Summerset Farms - Phase 4

A Lot Averaging Subdivision

A part of the Southeast Quarter of Section 28, T6N, R2W, SLB&M, U.S. Survey

Weber County, Utah

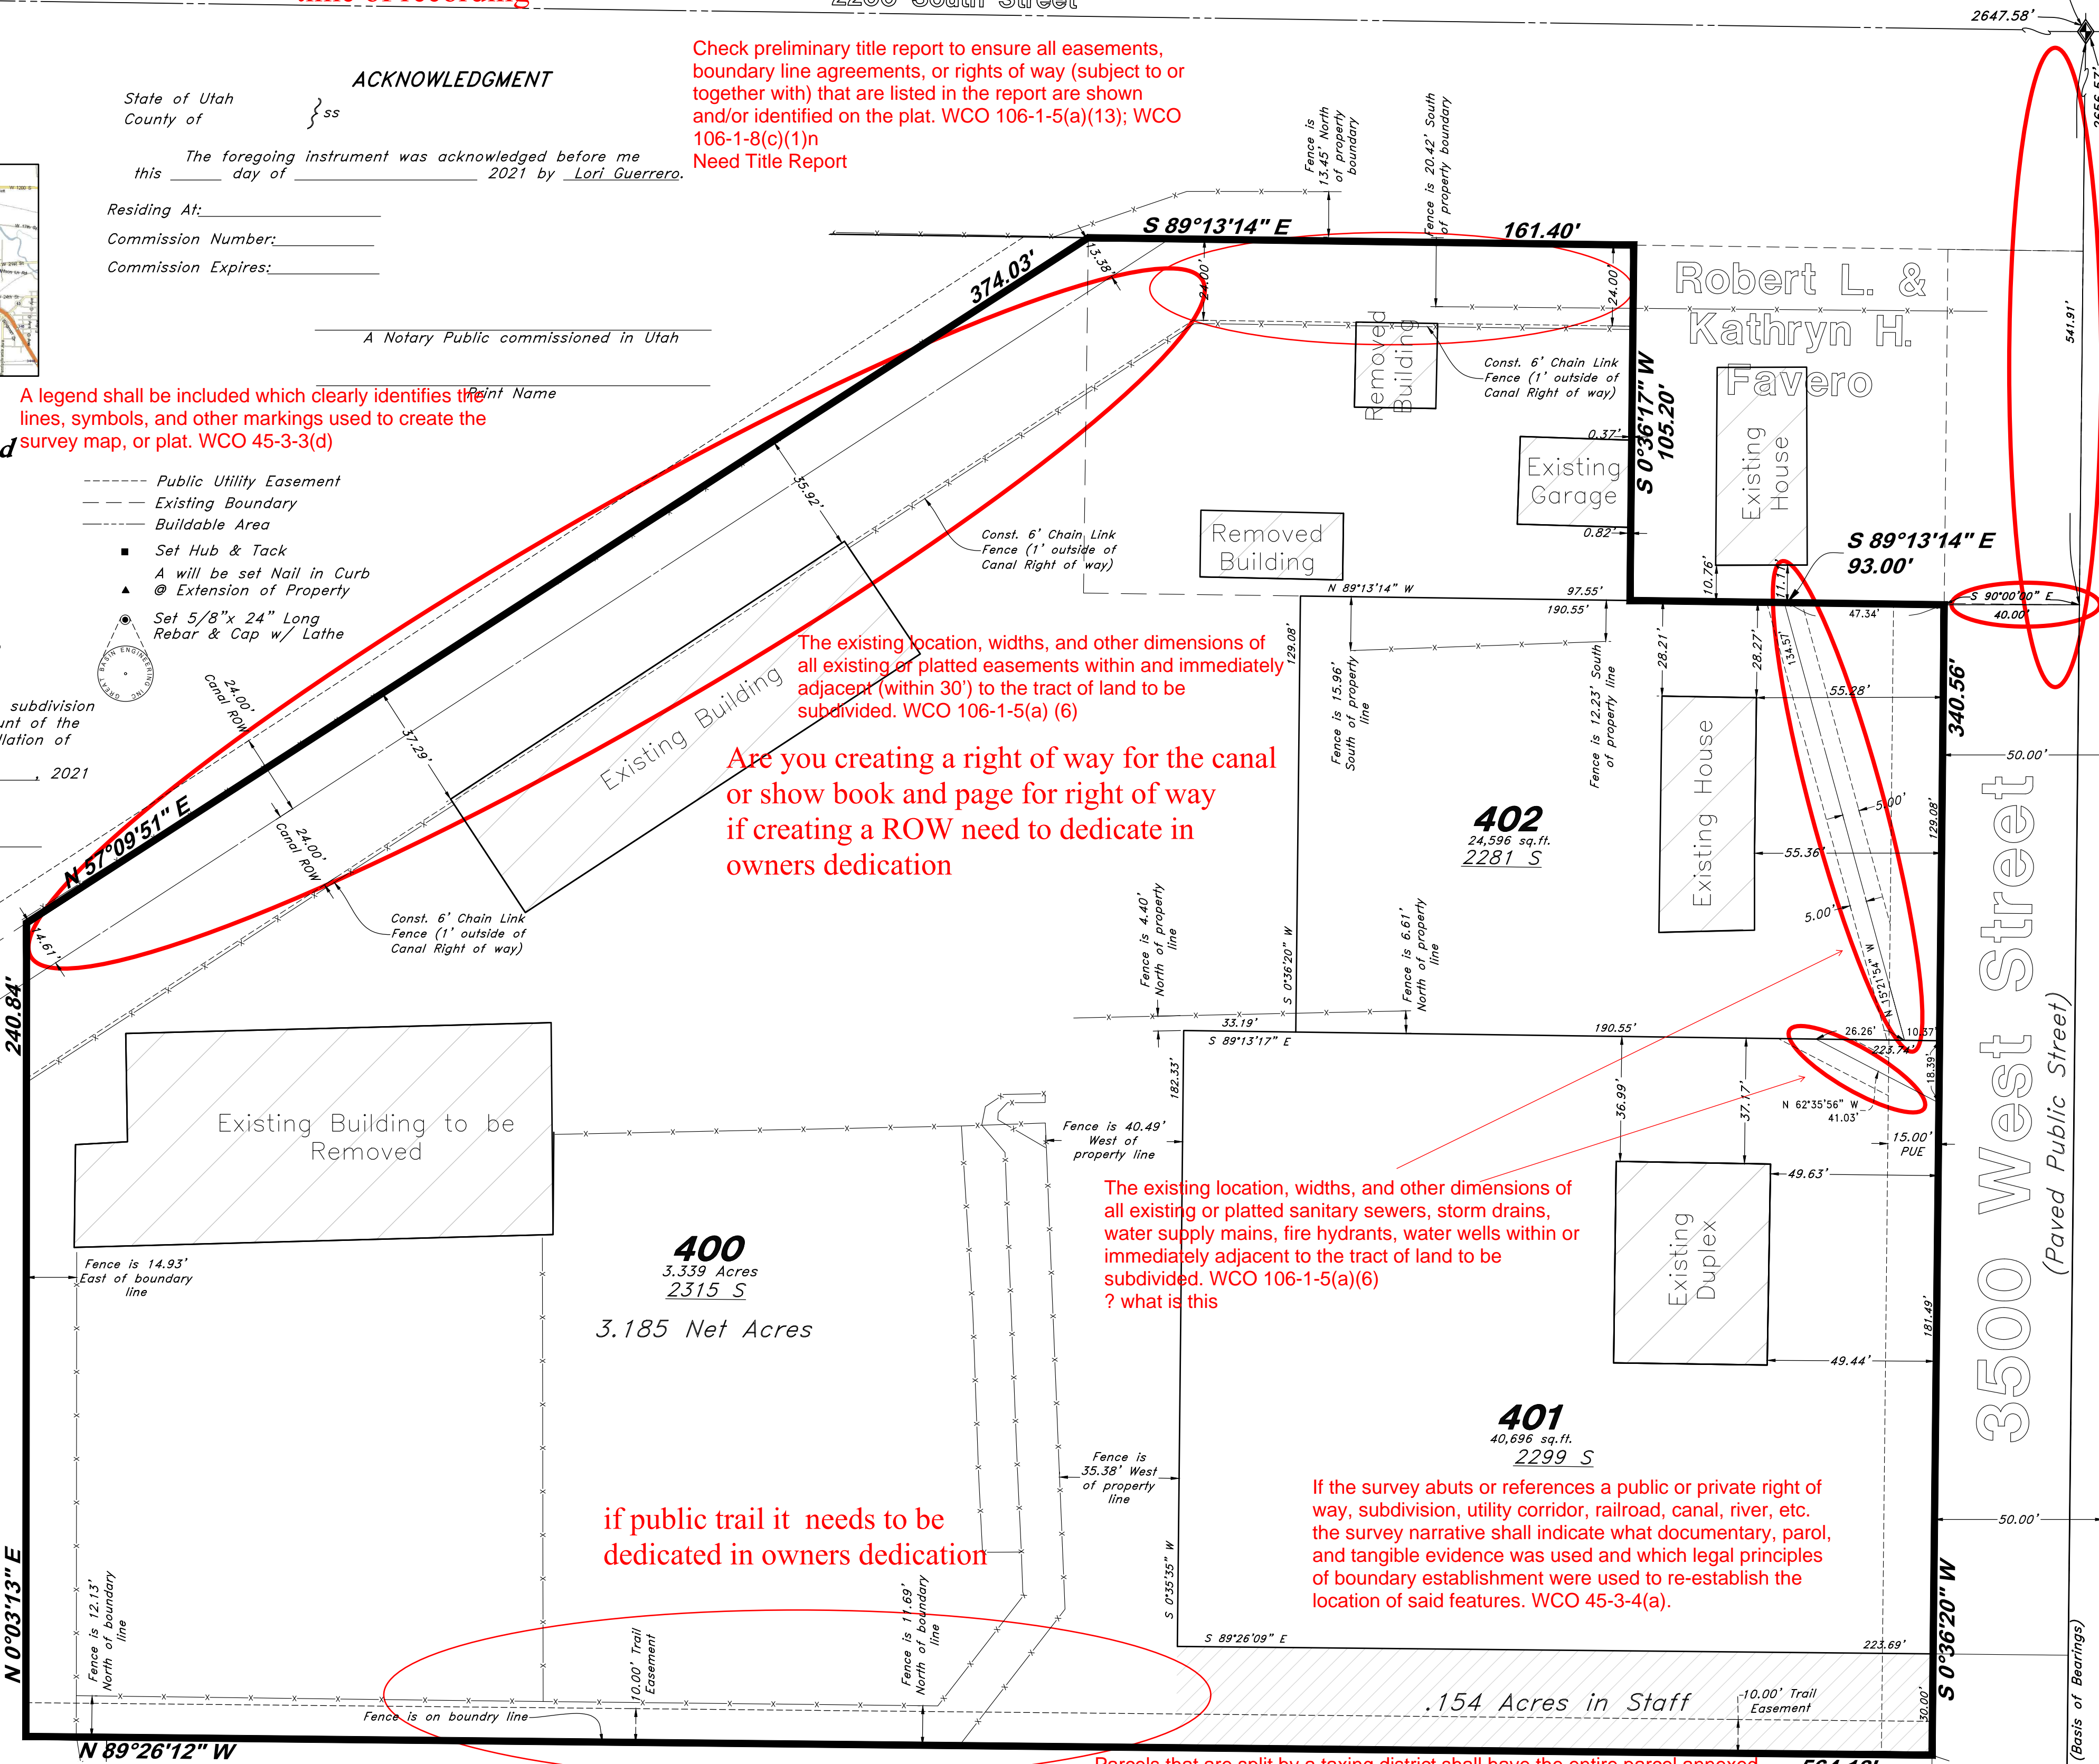
Deeds will be required before or @ time of recording

Check preliminary title report to ensure all easements, boundary line agreements, or rights of way (subject to and/or identified on the plat. WCO 106-1-5(a)(13); WCO 106-1-8(c)(1))
Need Title Report

A legend shall be included which clearly identifies the lines, symbols, and other markings used to create the survey map, or plat. WCO 45-3-3(d)

The existing location, widths, and other dimensions of all existing or platted easements within and immediately adjacent (within 30') to the tract of land to be subdivided. WCO 106-1-5(a) (6)

Are you creating a right of way for the canal or show book and page for right of way if creating a ROW need to dedicate in owners dedication

The existing location, widths, and other dimensions of all existing or platted sanitary sewers, storm drains, water supply mains, fire hydrants, water wells within or immediately adjacent to the tract of land to be subdivided. WCO 106-1-5(a)(6)
? what is this

if public trail it needs to be dedicated in owners dedication

Parcels that are split by a taxing district shall have the entire parcel annexed into that taxing district prior to the recording of the subdivision. Exceptions shall be made for bond obligations by the taxing district. WCO106-2-4(l) all annexations need to be approved before signing of plat do you need to annex into Hooper Water

Check names for all owners and acknowledgements
